# Staff Report

## Site Plan Review

SP-19-24

Proposal:	To construct a new 640-square-foot accessory structure.
Review Body:	Staff (Type I-L review)
Applicant/Property Owner:	Sean Murphy; 3776 NW 26th Avenue, Albany, OR 97321
Address/Location:	3776 NW 26th Avenue, Albany, OR 97321
Map/Tax Lot:	Benton County Tax Assessor's Map No. 10S-04W-26CD Tax Lot 02300
Zoning:	Residential Single Dwelling (RS-10)
Overlay Districts:	None
Total Land Area:	12,632 sq. ft.
Existing Land Use:	Residential
Neighborhood:	North Albany
Surrounding Zoning:	North: Residential Single Dwelling (RS-10) East: RS-10 South: RS-10 West: RS-10
Surrounding Uses:	North: Single-dwelling unit residential East: Single-dwelling unit residential South: Single-dwelling unit residential West: Single-dwelling unit residential

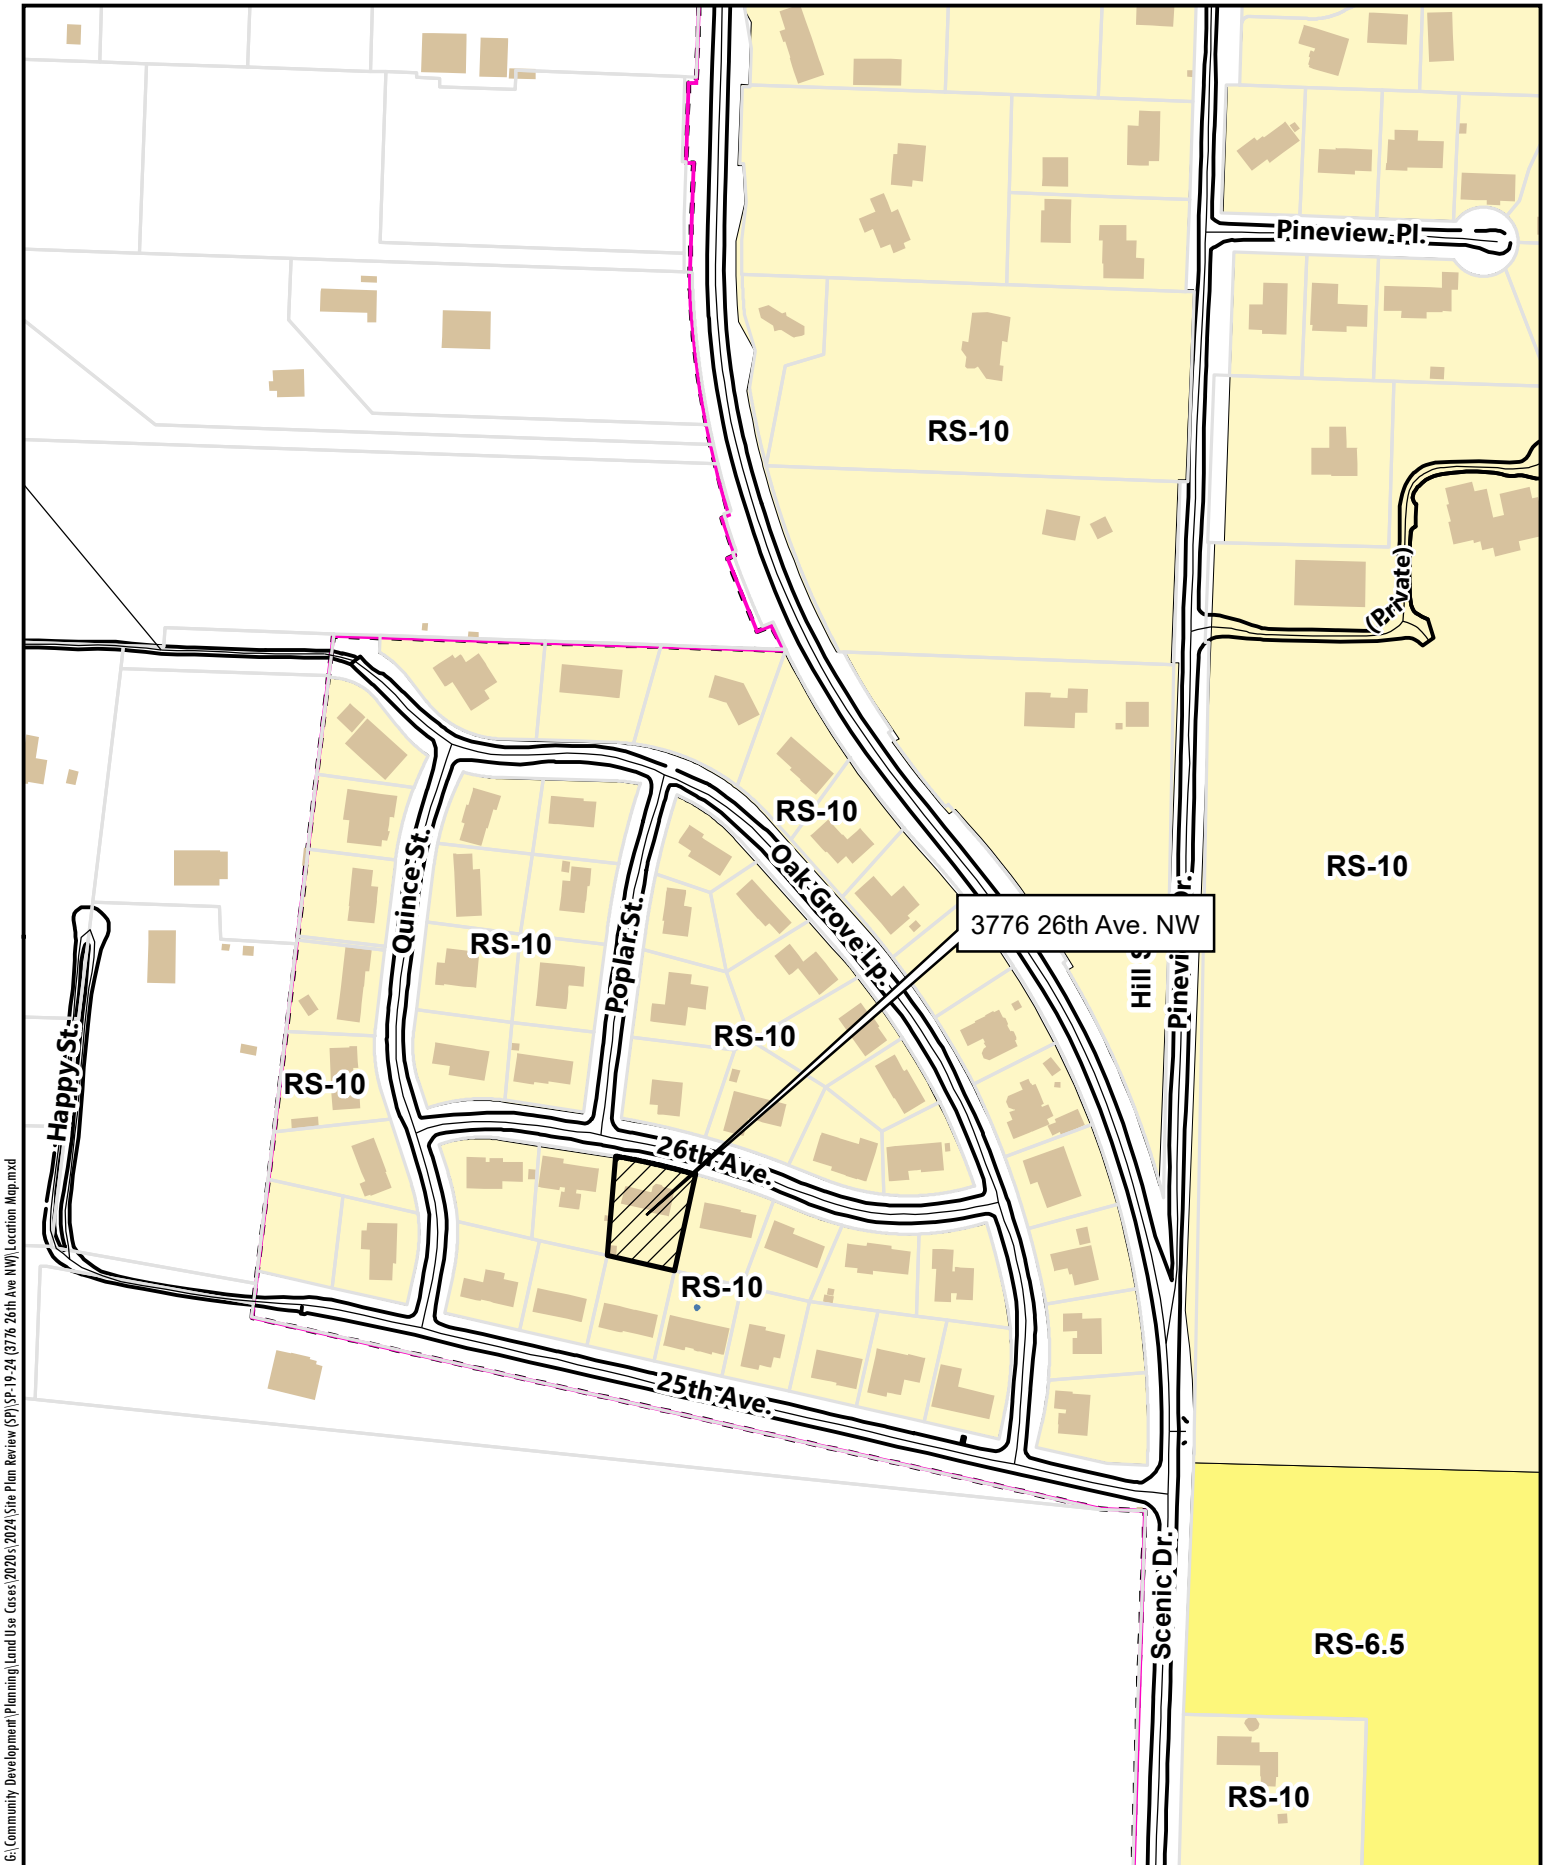
- 2.3 The submitted site plan (Attachment B) indicates the proposed accessory building will meet the minimum front setback of 20 feet and the interior setback of five feet.
